DEVELOPMENT ASSESSMENT REPORT	
Application No.	MOD/2020/0298
Address	140-142 Norton Street LEICHHARDT NSW 2040
Proposal	Section 4.55(2) Modification of Development Consent seeking various internal and external changes, including internal reconfiguration, changes to unit sizes, central courtyard amendments, relocated bike parking to basement and roof changes
Date of Lodgement	28 August 2020
Applicant	Lamton P/L C/O Design Delta Architects
Owner	Lamtom Pty Ltd
Number of Submissions	Nil
Value of works	\$2,476,811.00
Reason for determination at Planning Panel	Change to design change condition imposed by Panel for Development to which <i>State Environmental Planning Policy No 65</i> applies and is 4 storeys in height
Main Issues	Internal Amenity; Parking and Access
Recommendation	Approval
Attachment A	Recommended conditions of consent
Attachment B	Plans of proposed development

This report is an assessment of the application submitted to Council for Section 4.55(2) Modification of Development Consent seeking various internal and external changes, including internal reconfiguration, changes to unit sizes, central courtyard amendments, relocated bike parking to basement and roof changes a

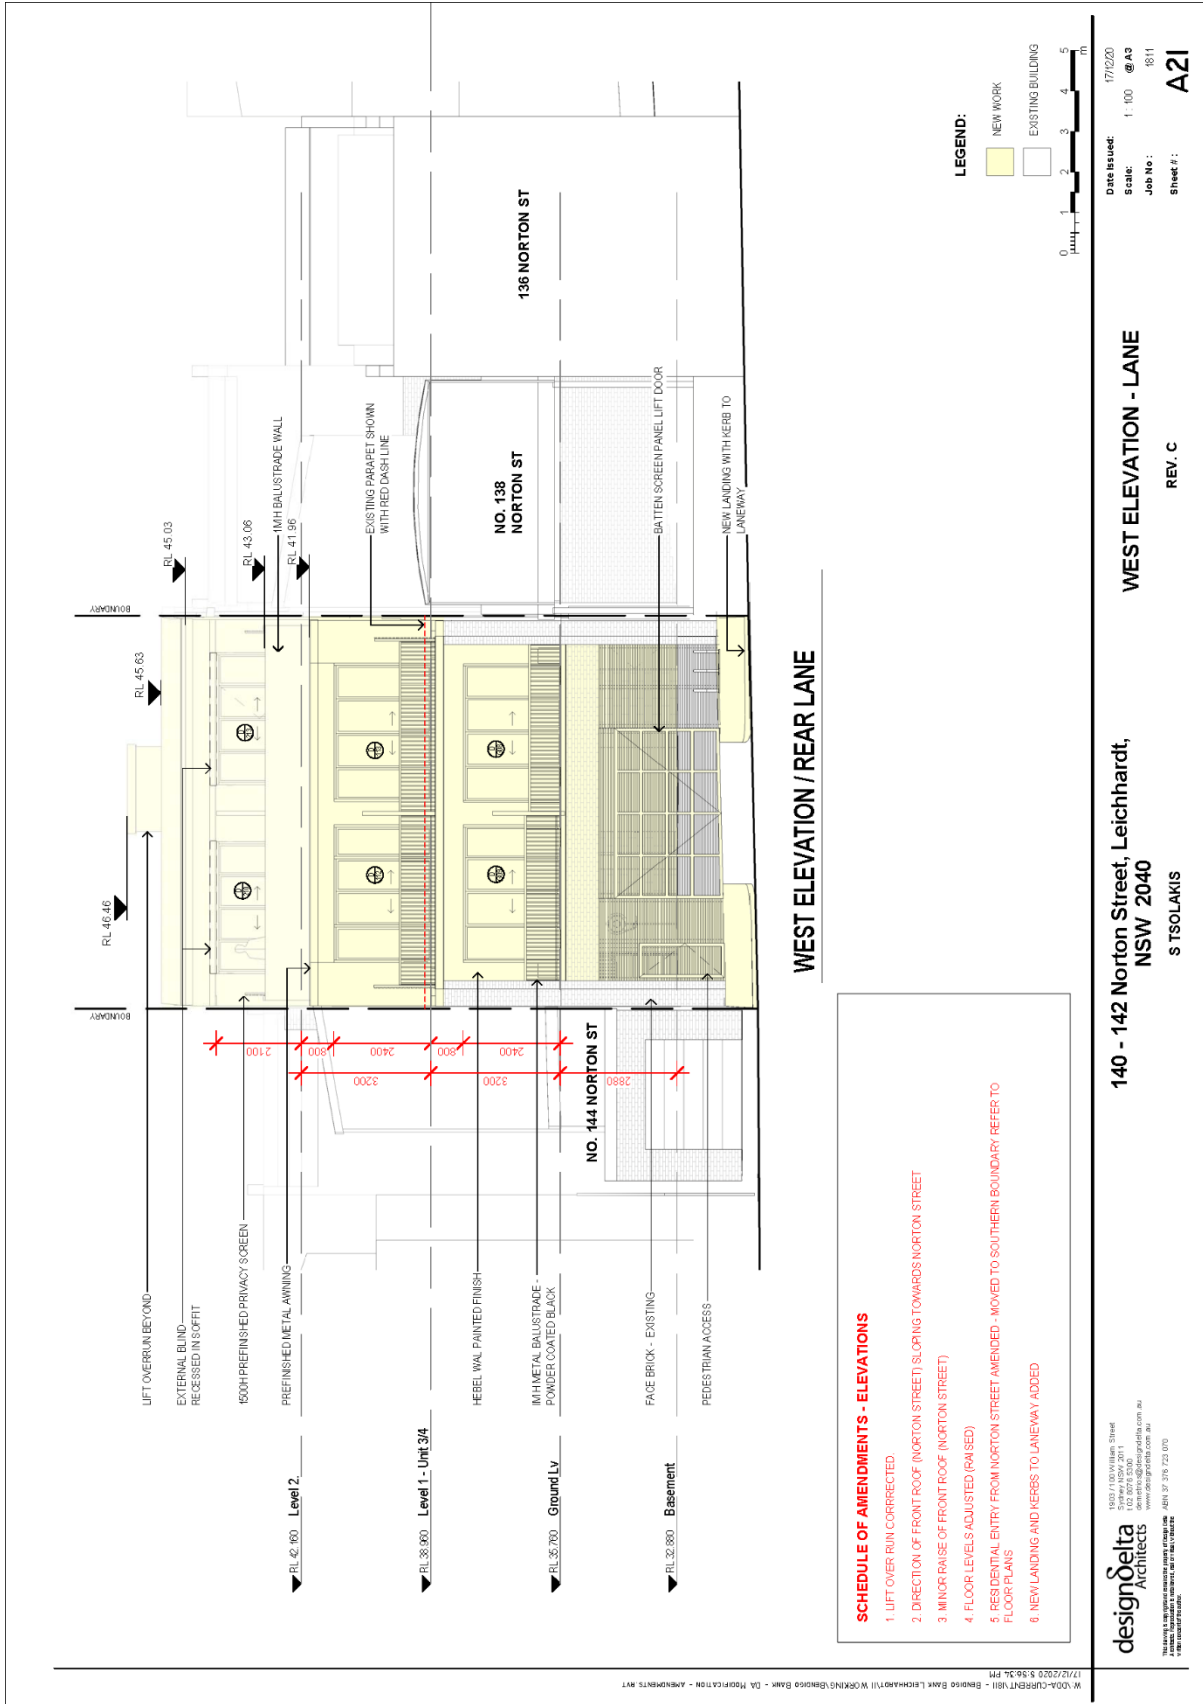
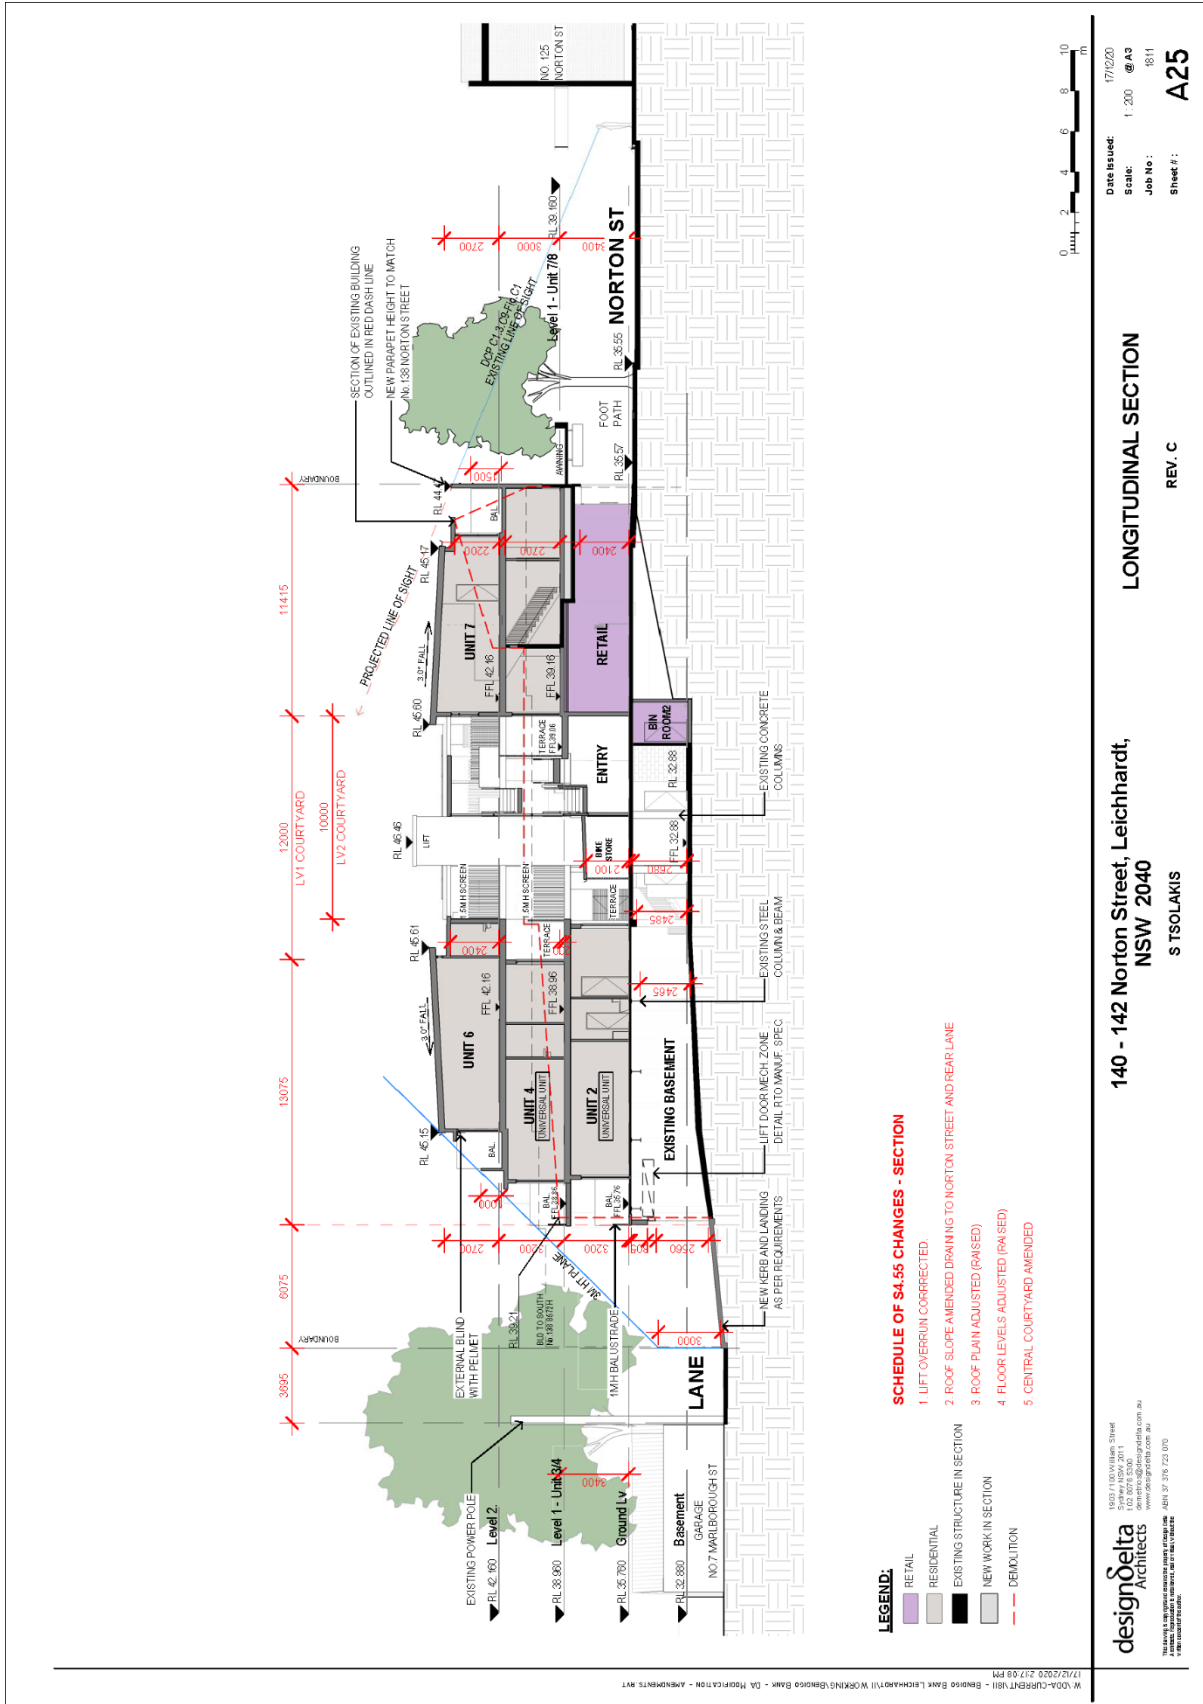
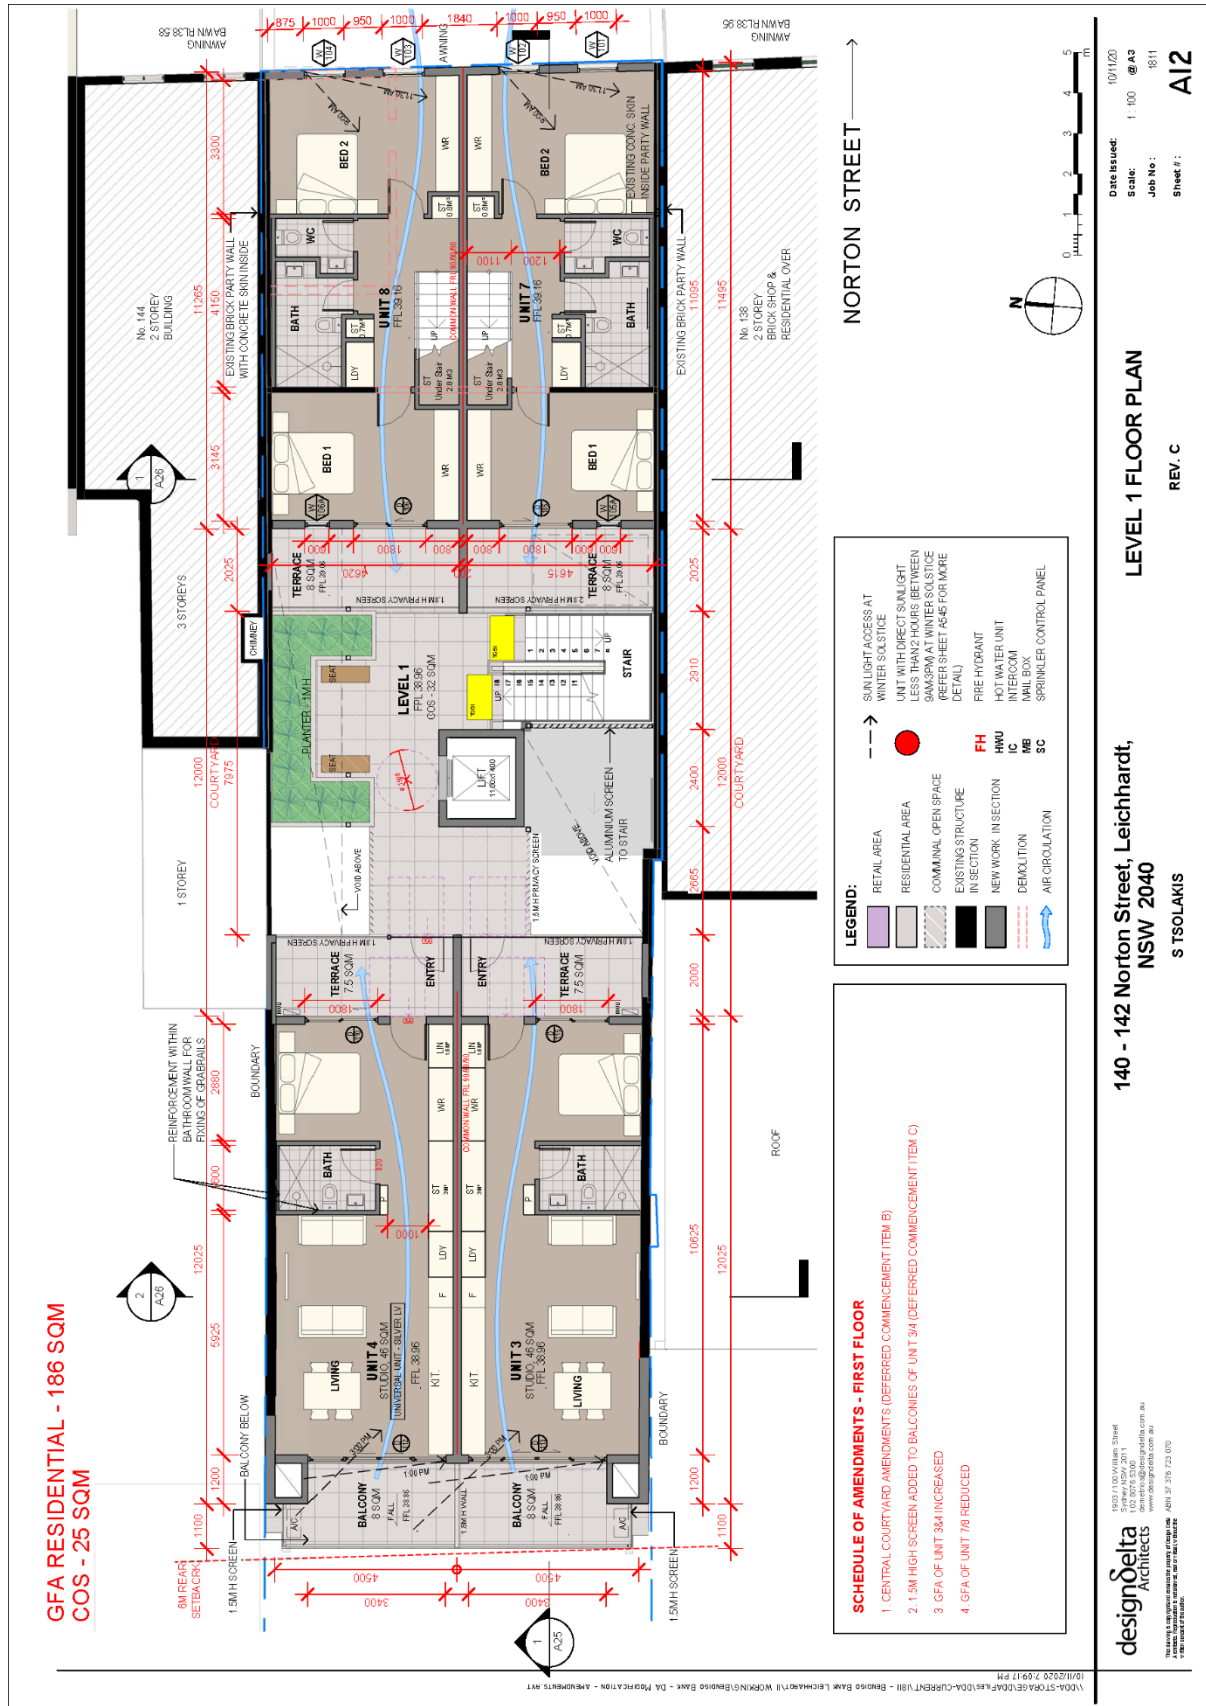
No changes were proposed to the overall parking provision originally approved and as such, Council's previous engineering conditions remain applicable.

However, given the amended plans incorporate the deletion of Car Spaces 5 and 6 as per conditions 28 and 31, these conditions will be updated accordingly as provided below:

- ~~g) *Parking Spaces Car 05 and Car 06 must be deleted as they do not meet the requirements of AS/NZS2890.1-2004.*~~

- ~~g) **Parking Spaces Car 05 and Car 06 must be deleted as they do not meet the requirements of AS/NZS2890.1-2004.**~~
- h) *Parking Space Car 04 must be allocated as a Visitor Parking Space for persons with a disability as per AS/NZS 2890.6-2009. Where the shared area is within a trafficable area, it must not be marked as per AS/NZS 2890.6-2009.*

- i) *Clear sightlines at the vehicular access to pedestrians and vehicles within the rear lane.*
- j) *The external form and height of the approved structures must not be altered from the approved plans.*
